ES SERVICE BULLETIN
Affected Equipment: YCAS, YCWS & YCRS Chillers
Shipped Before January 2006
Subject: Replacement DXS Compressor Motor Protection Circuit Modification
Issue Date: 7/06/07

"C" COMMON ON 2ACE MODULE
RESISTOR KIT INSTALLED ON 2ACE MOTOR PROTECTION MODULE IN SERIES WITH "C" COMMON

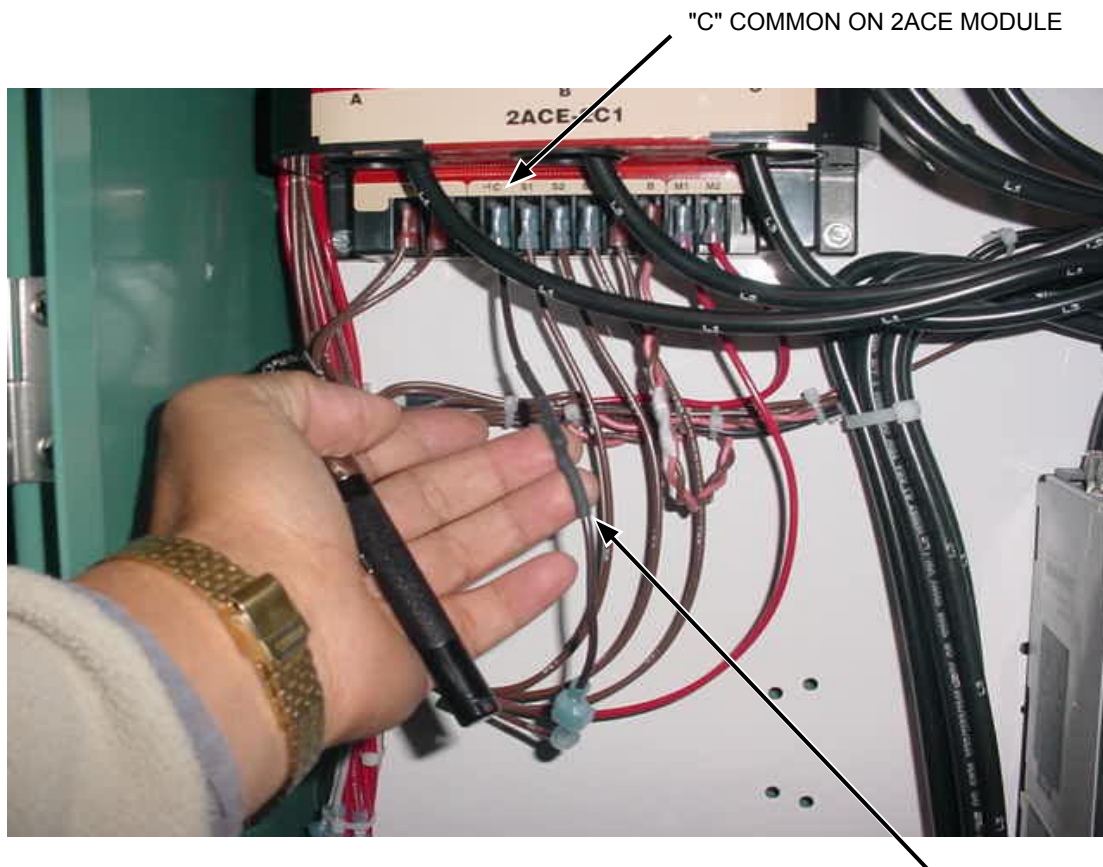
Any field ordered replacement DXS Compressor will include a 270Ω resistor for installation on the Klixon 2ACE Motor Protection Module located in the Power Panel. This resistor is installed in series with the “C” Common wire of this module as shown on page 2 of this Bulletin.

DXS screw compressors in chillers, or supplied as replacement compressors after January 2006, have thermistors imbedded in the motor windings which measure a nominal 50 to 150Ω at ambient. (Compressors manufactured prior to January 2006 have thermistors which measure a nominal 1200 to 1500Ω.)

To satisfy the Klixon 2ACE motor protector used on these chillers, install a 270Ω resistor to meet the minimum 150 to 200Ω input resistance.

Without the resistor, the 2ACE module will exhibit a code 5 'High Motor Temp' fault.
